Service Bulletin

Ref No: RAC-0109

Product: Ceiling type indoor unit

Subject: Service part changeover for assembly efficiency improvement:
Gearbox sub assy

Changes in the structure of the Gearbox sub assy (including stepping motor)

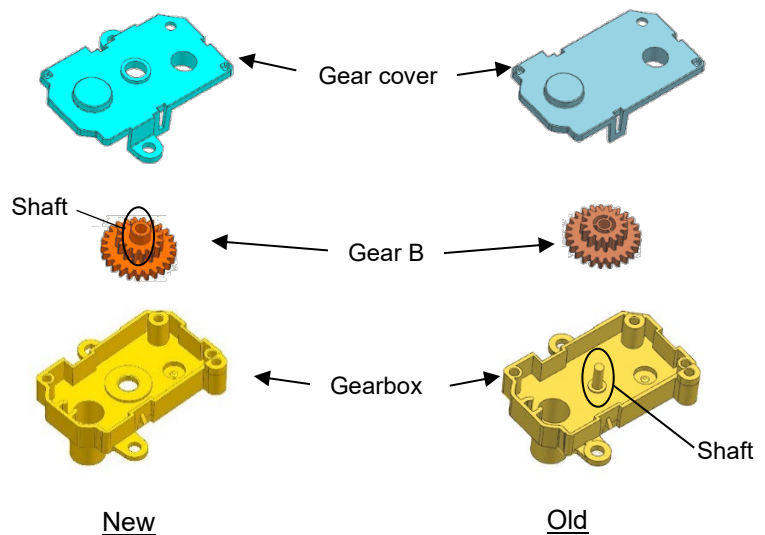
- The gear cover and the gearbox are fastened together to close the gear cover securely.
- A new hole in the center of the gear cover allows the state of the gear B assembly to be checked.

Fastening the cover and the box together with screws

Part	Part number	
	Old	New
Gearbox sub assy (including stepping motor)	9384312006	9384312013
